Assessment Officer Report

PA2403197 – 977 Burwood
Highway, Ferntree Gully.

Officer Assessment Report
Development Approvals & Design

Department
of Transport
and Planning

Figure 20: Section through the middle school.

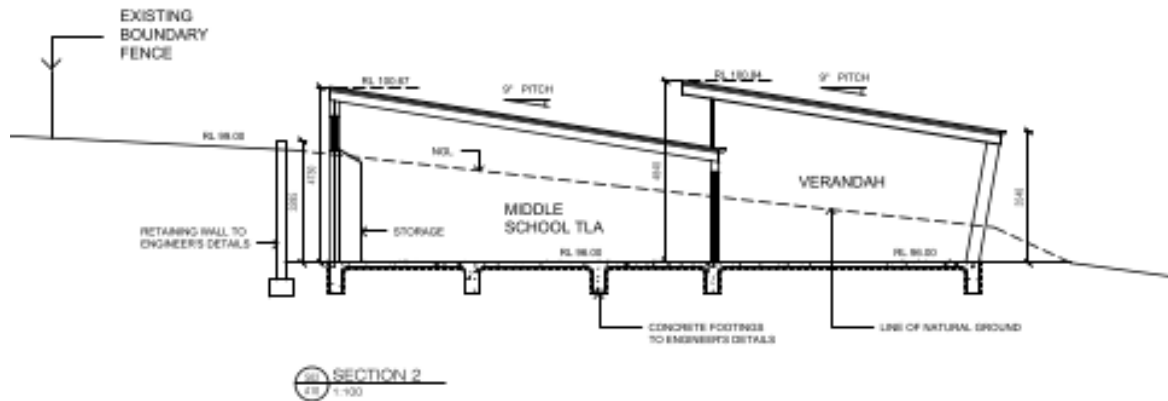
- 62. The site has significant fall from east to west. The location of the new Middle school classrooms and the MPC are along the eastern boundary and set into the hill through the use of a site cut. This results in the built form being

located below the adjacent fence line, resulting in minimal impact to views from adjoining properties located to the east.

Figure 21: Section through MPC

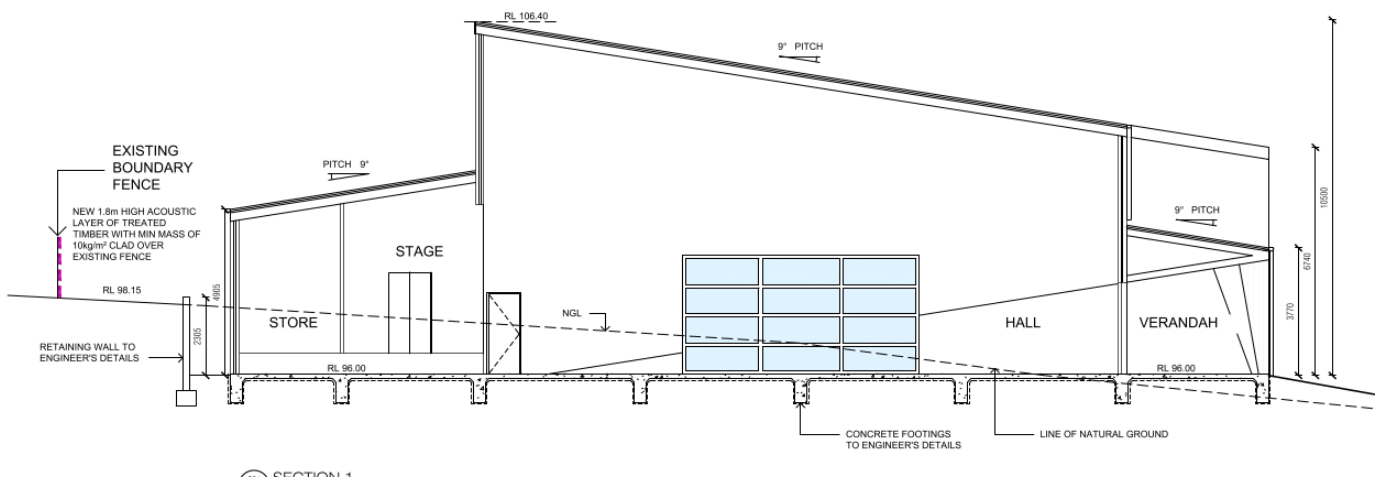
63. The MPC is also located along the eastern boundary, cut into the site. In addition to the setback from the boundary the highest part of the building is setback an additional 12.3m from the boundary fence.

Figure 23: Proposed driveway configuration

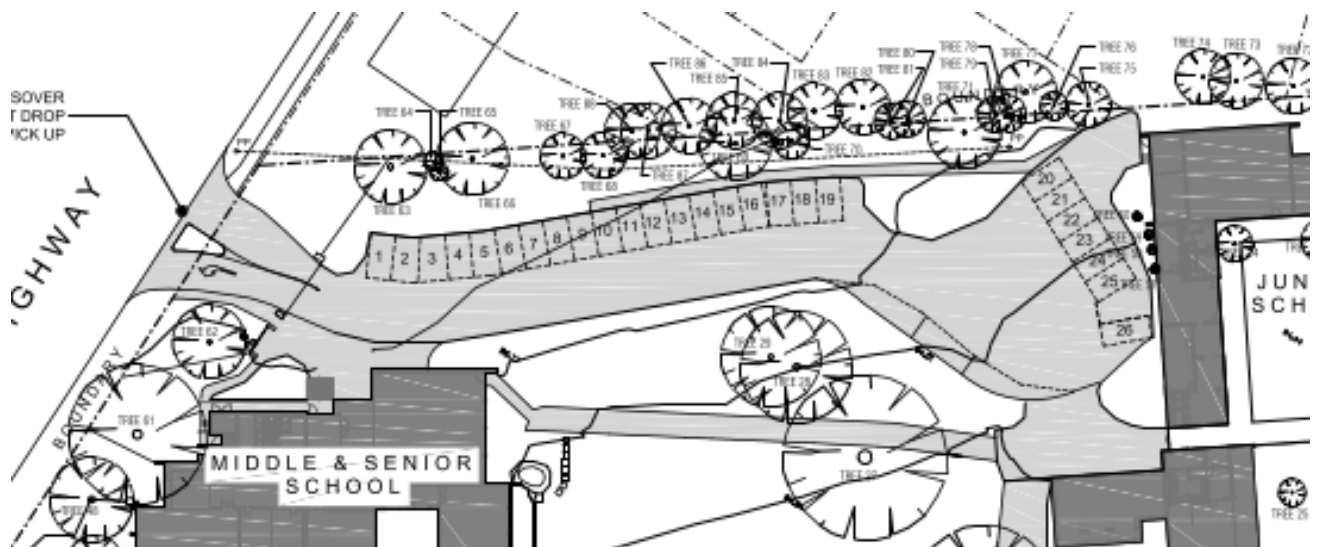
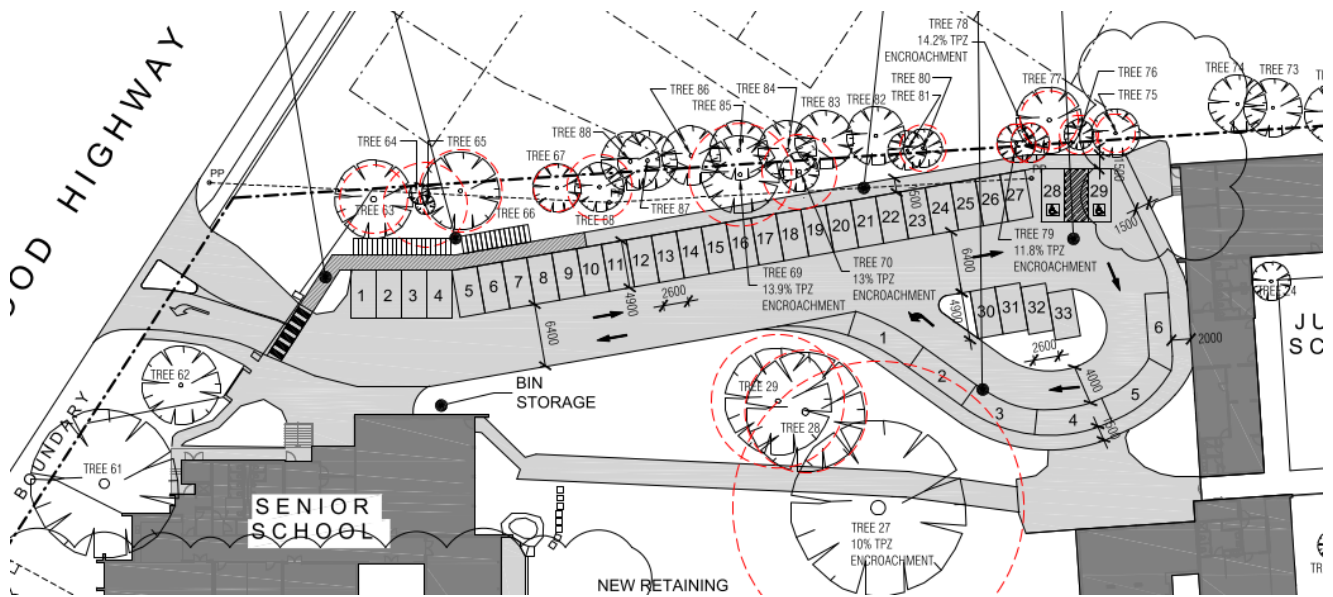
72. The new access arrangements will assist in a reduction of parents queuing on Burwood Highway by creating greater circulation space within the school property and easier drop off arrangements. This is in addition to the school implementing staggered drop of and pick up times for different year levels.
73. The proposed change is an acceptable and will improve the daily operation of the school site.

Figure 24: Location of acoustic fencing

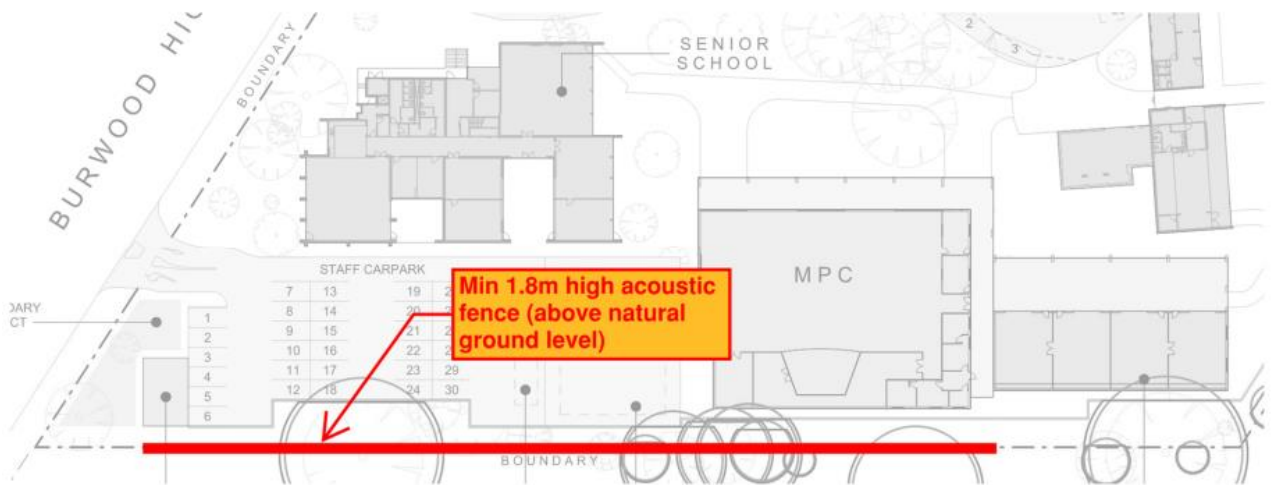
76. The amenity impacts to the adjoining properties will be minimal with the majority of noise generated during the day. The application was submitted with an acoustic report to demonstrate the noise generated by the additional buildings will not create any further unreasonable noise impacts to the adjoining residential properties. Mechanical plant equipment has not been shown on the plans, this will be required to be shown via a permit condition.
77. The acoustic report provides guidance on installing a new 1.8m high acoustic fence along the boundaries with adjoining properties to provide a barrier between the MPC, COLA and new car park.
78. The acoustic report provides some guidance on times for the use of outdoor areas and the MPC, the proposed times are as follows:

- 7am to 6pm (Monday to Friday)
- All windows must be kept closed during court use.

79. Conditions will be included in any permit issued to control noise emitted from the new uses.

Figure 25: Proposed landscaping plan

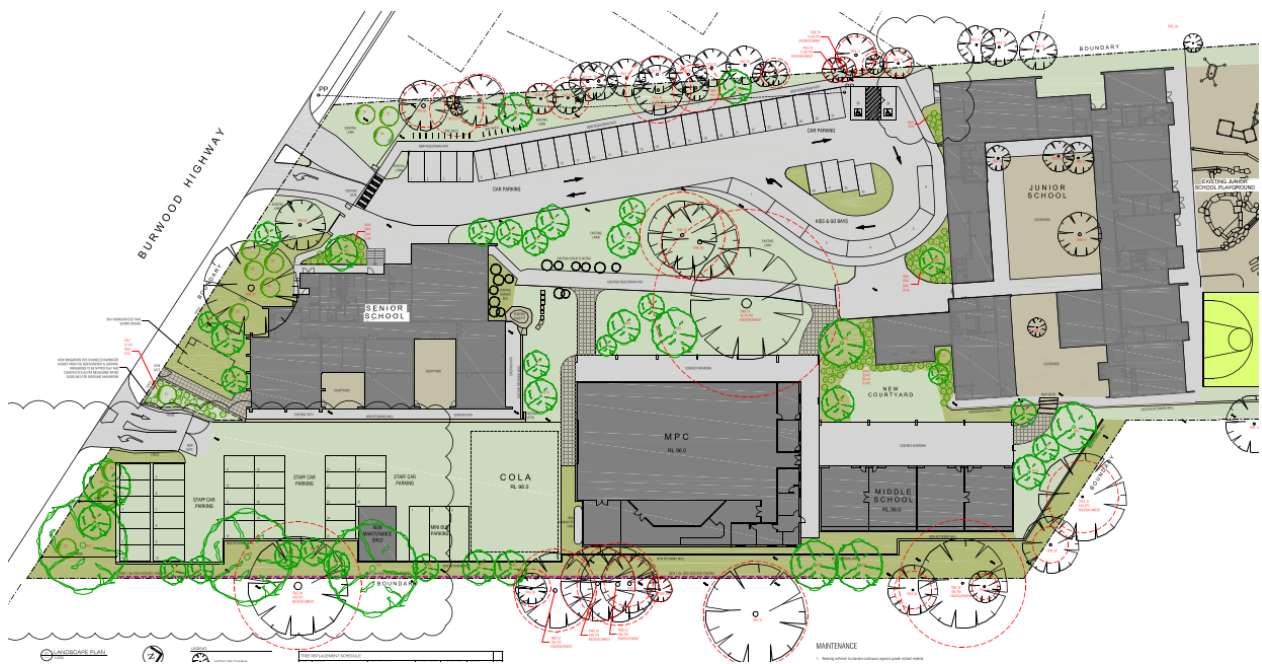
87. The overall planting of canopy trees proposed is consistent with the existing landscaping within the school grounds. In addition to the proposed landscaping it will be conditioned that new screening planting will be planted along the new fence line separating No. 8 Winwood Drive and the maintenance shed creating additional screening measures and along the eastern boundary adjacent to the Middle School building and the MPC.
88. The landscape plans will be required to be updated to include this additional screening and to show the correct location of the new pedestrian gate and associated path from Winwood Drive.

31. Prior to the commencement of the development, amended landscape plans prepared by a suitably qualified person must be submitted to the Responsible Authority for approval. The amended landscape plans must be generally in accordance with the landscape plans by Spacecraft dated 4 September 2024 with the following changes:
 - a) Screening planting to be located along the new fence separating the maintenance shed and the dwelling located at 8 Winwood Drive.
 - b) Screening planting to be located along the eastern boundary between the boundary fence and the retaining wall adjacent to the MPC and Middle School buildings.

- c) Plans updated to include the modified location of the pedestrian gate to Winwood Drive.
 - d) Tree Protection measures provided for all existing trees to be retained (neighbouring and subject site).

- e) The extent of 'Strata Cell' installation shown.
 - f) Notation requiring drip irrigation to be provided to all new plantings.
 - g) Separate planting schedule for raingarden, revised to replace Anigozanthos sp. And Carpobrotus modestus with more suitable species and to be in accordance with the below.

- h) At least 50% of the vegetation species located in the raingarden should comprise of some or all of the following: Carex sp, Juncus sp, Melaleuca and Goodenia. This ensures adequate removal of Nitrogen and Phosphorus. Low and tufting plans proposed for the raingarden must be plated at a minimum density of 6 plants/sqm.
